**RE: CENTEX IMPROVEMENTS (D17-D76). UPDATED GRADING
AND DRAINAGE PLAN FOR BUILDING PERMIT APPROVAL.
ENGINEER'S STAMP DATED FEBRUARY 20, 1998.**

RE: CENTEX IMPROVEMENTS (D17-D76). DRAINAGE REPORT FOR BUILDING AND SO #19 PERMIT APPROVALS. ENGINEER'S STAMP DATED DECEMBER 8, 1997.

RE: DRAINAGE PLAN FOR CENTEX IMPROVEMENTS (D17-D76) ENGINEER'S PLAN
DATED 10/31/97

DRAINAGE PLAN & REPORT for IMPROVEMENTS & ADDITIONS
at
CENTEX AMERICAN GYPSUM, ALBUQUERQUE NM

Attachments

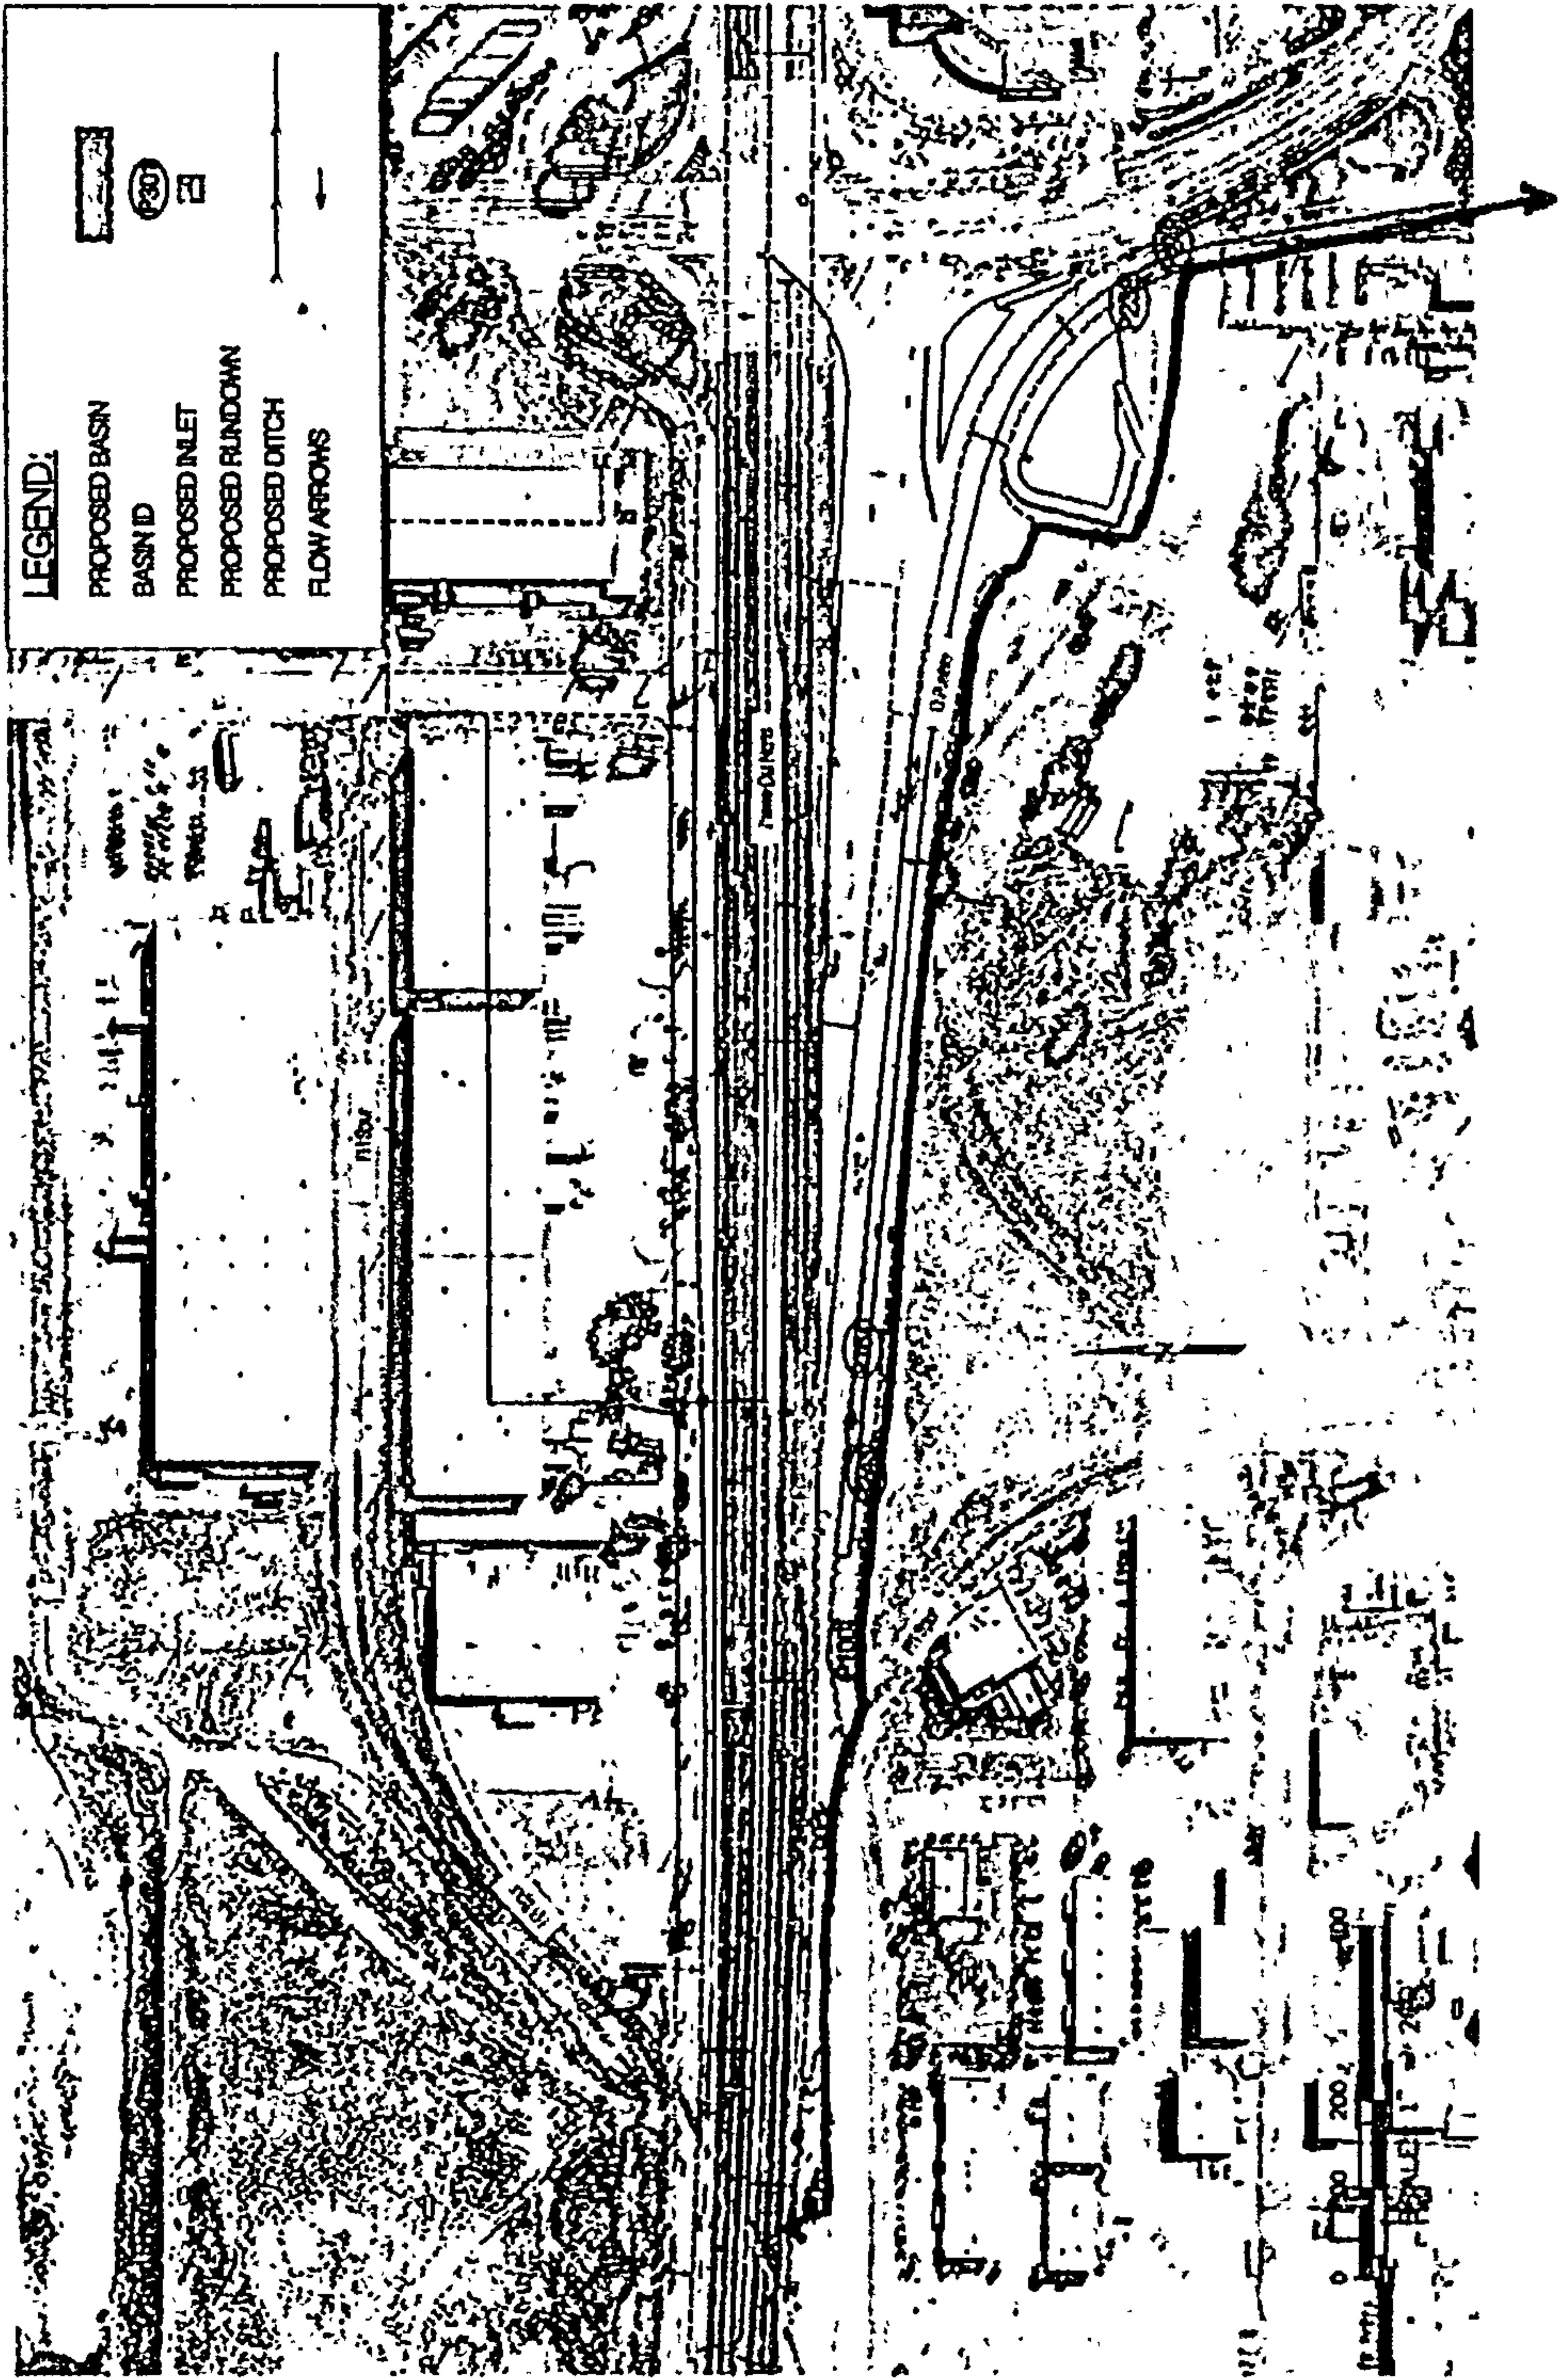
It is our understanding, via the City's representative for the PDN/I25 project, that the drainage basin upstream of Tiburon St. is being completely intercepted in Tiburon St. and routed to the new surge ponds being constructed on the southwest corner of Jefferson St. and Paseo del Norte. Secondly, it is our understanding that the surge ponds will fully contain the 100-year storm and will not discharge any flow west along El Pueblo. Finally, all the roadside and roadway flow in El Pueblo between your BOP and the surge ponds will be collected by new drop inlets east of your BOP, resulting in virtually no discharge at your BOP (see attachments).

It would be greatly appreciated if you can confirm our understanding of the final drainage conditions resulting from the PDN/I25 project by signing on the concurrence line provided below. This will allow us to move forward with the design of the storm drain within El Pueblo west of the PDN/I25 project limits.

NMDOT Concurrence Date 6/30/14
